Job Number: **21NL155-A1**

Date: **13th August, 2021**

Access Review Report for **67 Mars Rd, Lane Cove West, NSW**

The purpose of this report is to provide an accessibility review of the subject development to ascertain whether the development is consistent with access to premises requirements for the proposed business centre development.

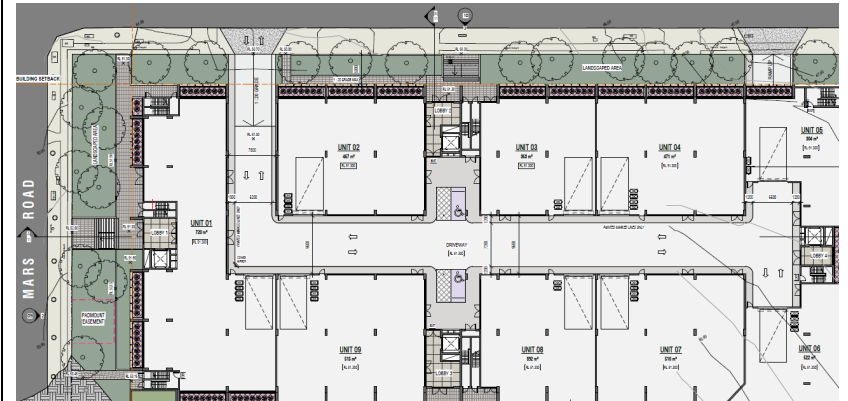
BCA Clause	Compliance	Comments/ Recommendation
Part D3 Access for People with Disability		
D3.1 General building access requirements		
<div>Class 7a – car parking</div> <div>To and within any level containing <i>accessible</i> car parking spaces</div>	<div>Complies</div> <div>Details to be verified at CC stage of works</div>	<div>Access provided to accessible car parking spaces in all the levels via footpath, lobby and lifts</div> <div></div>

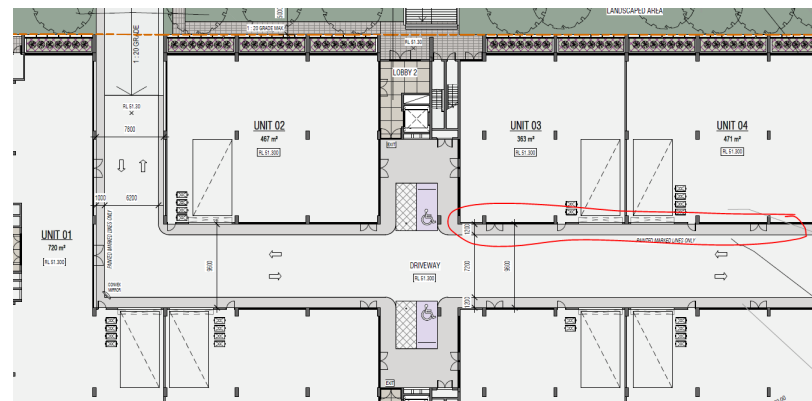
1.2m wide painted marked line is provided on all the levels from the driveway at boundary to each unit's entries.

accessible path is provided from footpath & from parking spaces to all unit entries

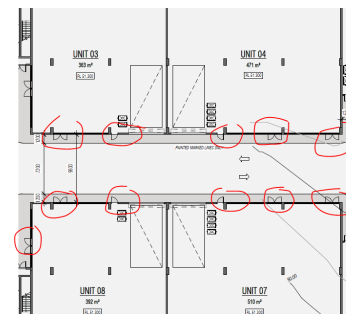
Multiple accessible doorways are provided for all the units on all the levels

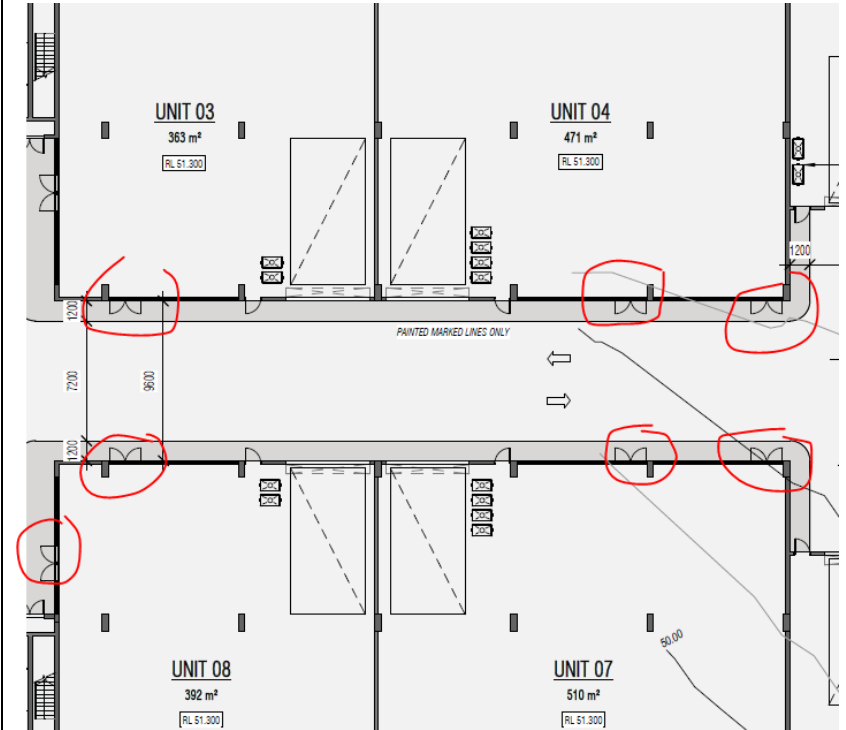
multiple leaves (or double leaf) doors are provided for all the units and lobby with both of the leaves having a clear opening min of 850mm in all the levels

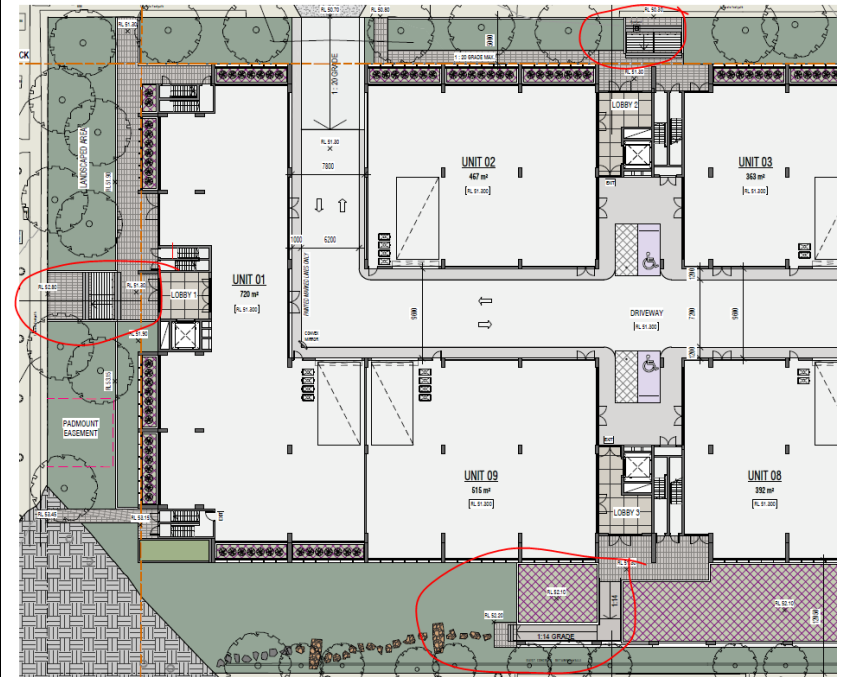
Stairways and ramps complying with AS1428.1 are provided on level 1

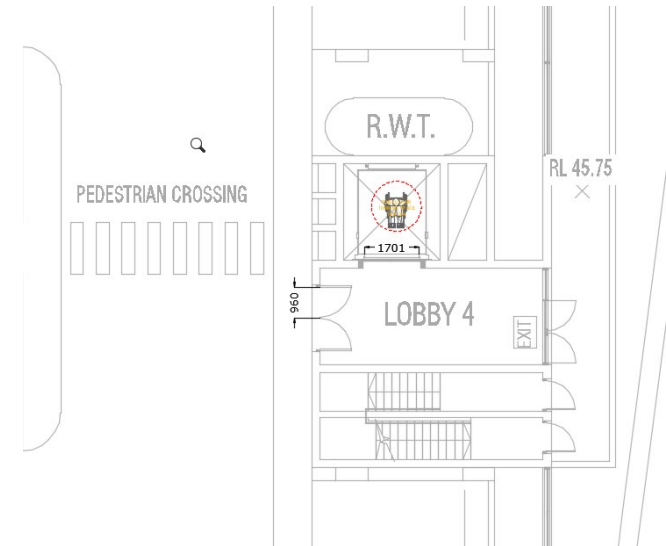
Four passenger lifts complying with BCA, E3.6 are provided

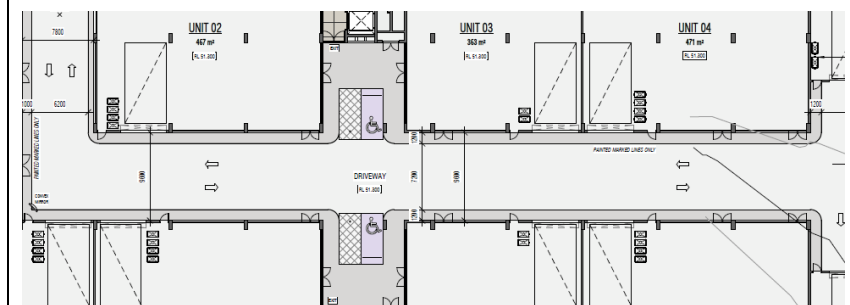
A wide 1.2m painted marked line is provided throughout the boundary which can be used as a passing space as there is no level difference between these marked lines and the driveway

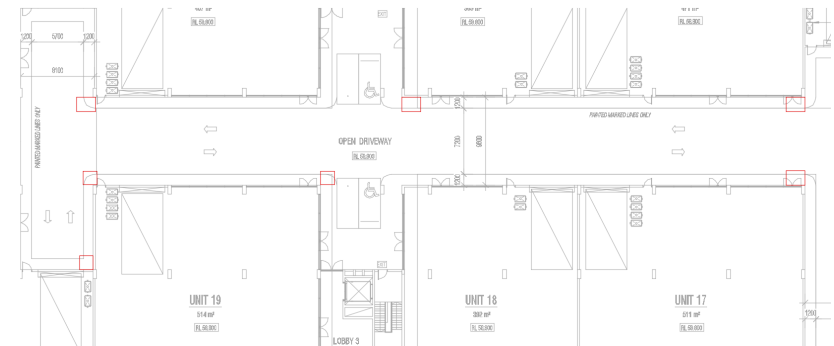
Wheelchairs can make 90 and 180 degrees turn in all the corners

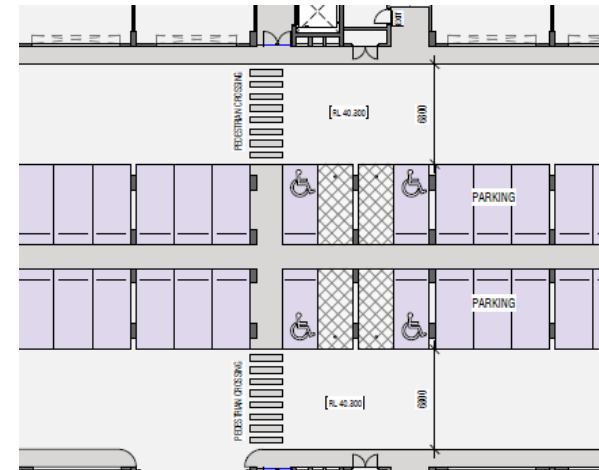
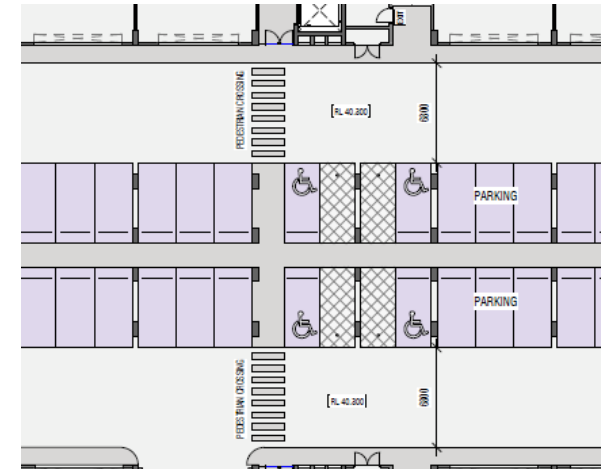
16 disabled car spaces complying with AS 2890.6 are provided for the proposed business centre

16 disabled car spaces complying with AS 2890.6 are provided

All disabled parking spaces are complying with AS2890.6.
